H10973

DESCRIPTIVE REPORT

General Locality Northern Shelikof Strait

Sublocality Kukak Bay

Figure 3: H10973 Survey Junction

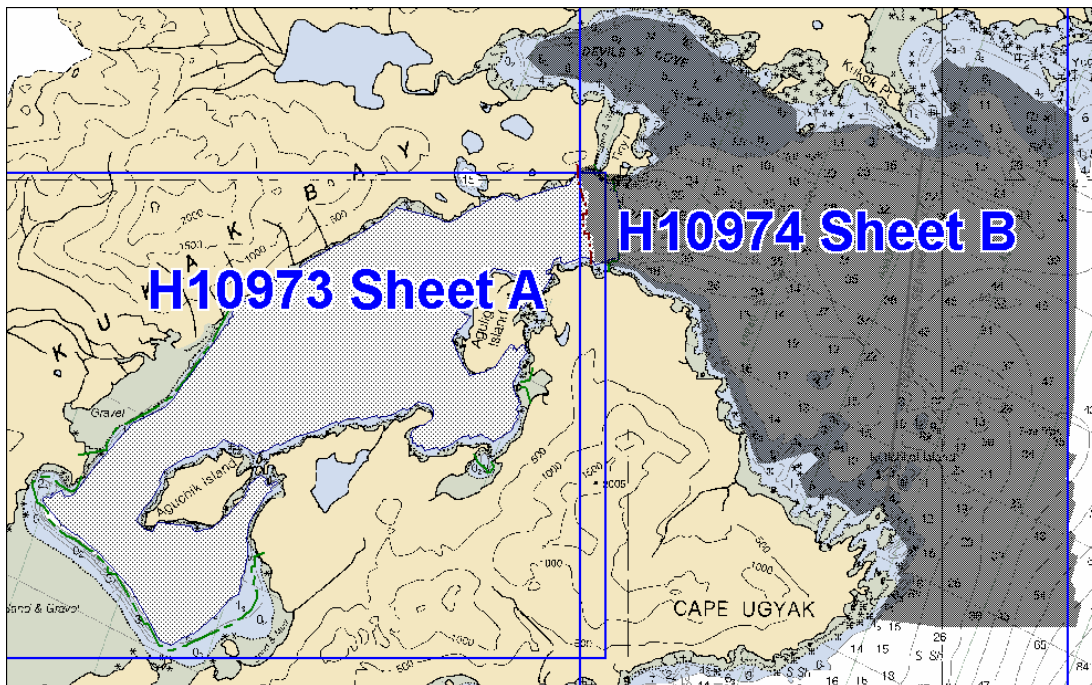
There were no gaps in coverage between H10973 and H10974. Soundings from the two surveys agree within one fathom. Final comparisons will be made at the Pacific Hydrographic Branch (PHB) after the application of smooth tides.

⁸ PHB Revision-The junction with H-10974 is complete. Soundings and depth curves are in good agreement. A few soundings and features have been transferred within the common area to better delineate the bottom configuration. A "JOINS" note has been added to the smooth sheet.

Figure 4: HDCS subset from SW Kukak Bay.

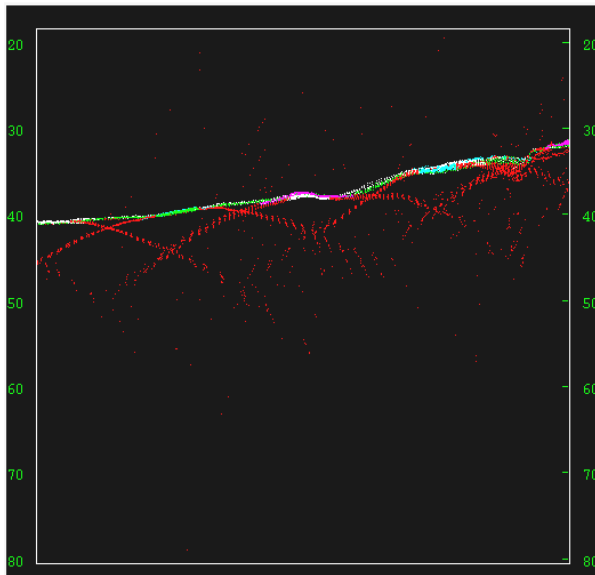
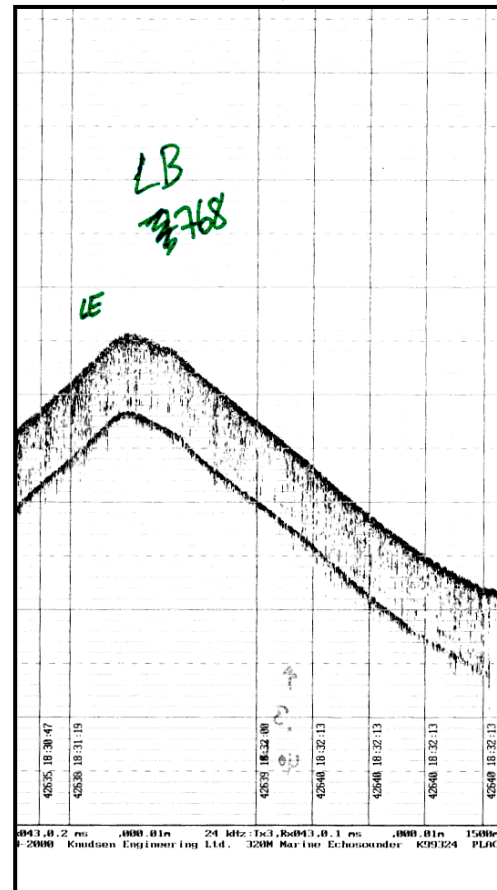
During shallow-water multibeam data acquisition using the Reson SeaBat 8101 system at the southwest end of Kukak Bay, south of Aguchik Island, the outer beams were observed curving downward on the real-time display windows in Isis, as well as in CARIS subset mode following full correction for attitude, sound velocity, tide, and draft. Suspended sediment in the water column was believed to be the cause. This area is located at the head of the bay where several streams deposit sediment. The SeaBeam/Elac system was then used to acquire full-bottom coverage data in the area, to determine if the difference in bottom-detection methods between the Reson and Elac/Seabeam systems would have an effect on the “frowning” due to the nature of the sediment. The outer beams were still observed curving downward in real-time monitoring, although the “frowning” was less obvious. In HDCS subset mode, the shallow-water multibeam data acquired on DN 145 by VN 2121, DN 172 by VN 2126, DN 173 by VN 2126, DN 174 by VN 2126, and DN 174 by VN 2124 were filtered to 45° off nadir, instead of the standard 60°, to compensate for the outer beams curving downward. (See Figure 4 for an example of the outer beams curving downward in HDCS subset mode.)

For the purpose of quality assurance, VBES data were also collected simultaneously with the shallow-water multibeam data by VN 2124 at the head of Kukak Bay. A noticeable double trace was observed in the VBES analog paper record, indicating sediment slurry at the bottom and confirming the Hydrographer’s opinion that suspended sediment was likely to blame for the profile viewed in the SWMB data. (See Figure 5 for an example of the VBES analog trace from VN 2124 on DN174). The VBES

soundings were digitized from the top of the double trace. VBES data compared within one meter of the final SWMB dataset.⁹

⁹ PHB Revision-Based on the comparison of SWMB systems between vessels 2124 and 2126, the VBES data was not part of the final data set in the areas of overlapping coverage.

Figure 6: Migration of sand bar at the head of Kukak Bay

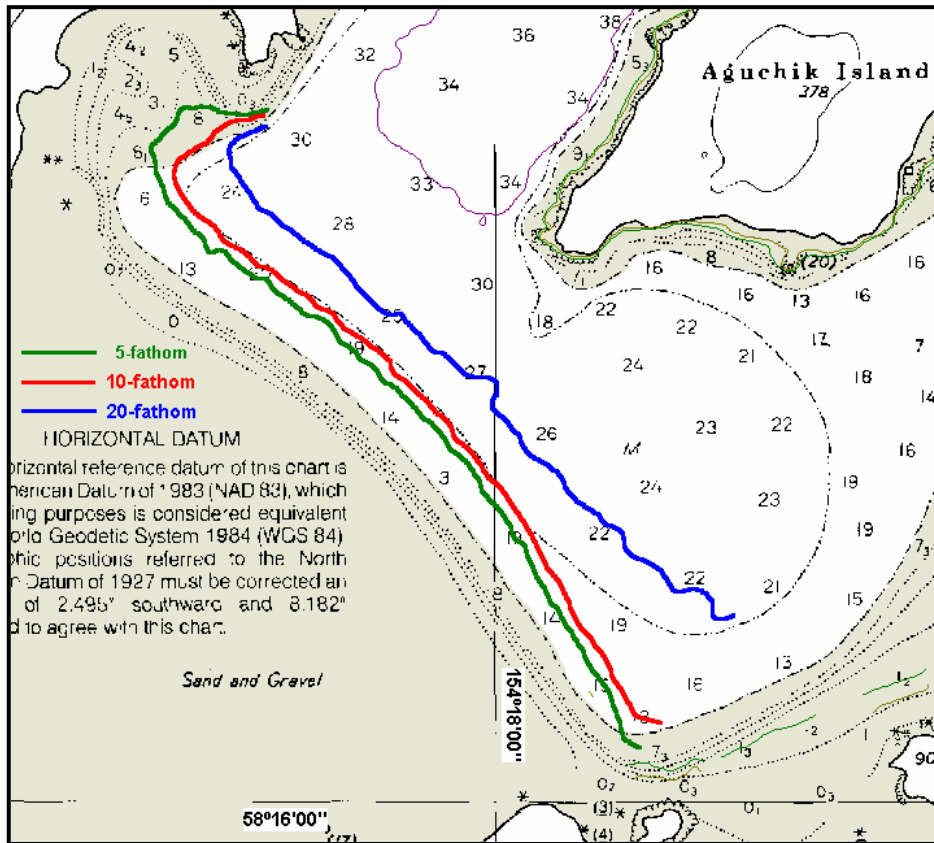
The mud flats along the west shore of Kukak Bay have migrated approximately 150 to 300 meters seaward. Each of the corresponding contours has migrated an equivalent distance from shore, and therefore survey depths were 10 to 15 fathoms shoaler, on average, than charted depths in this region. It was also apparent that the 0-fathom contour, although not specifically surveyed, has also migrated offshore, and therefore the Hydrographer recommends charting an approximate 0-fathom curve¹⁹ as depicted on the Final Field Sheet. The Hydrographer also recommends including a notation on all charts of Kukak Bay that the mud and gravel bars are subject to migration and that mariners are advised to use caution when navigating this region.²⁰

¹⁹ PHB Revision- An approximate MLLW depth curve has been shown on the smooth sheet based on the field sheet and final plotted soundings.

²⁰ PHB Revision-Concur
